MAXIMUM CARTRIDGE / MINIMUM CHAMBER

12-GAUGE - 23/4"

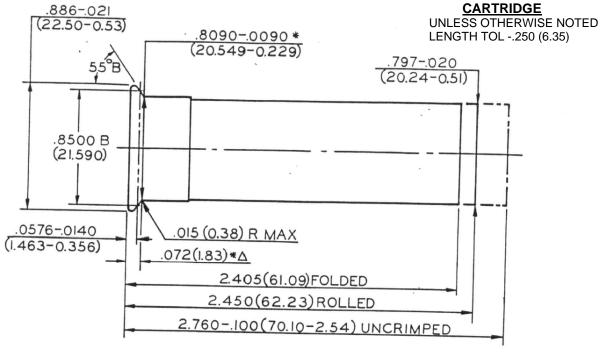
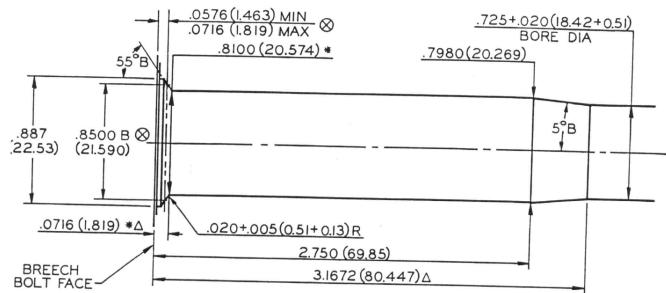
CHAMBER LENGTHS HAVE BEEN INCREASED. FORMER CHAMBER DIMENSIONS ARE ALSO CONSIDERED TO REPRESENT SAFE PRACTICE.
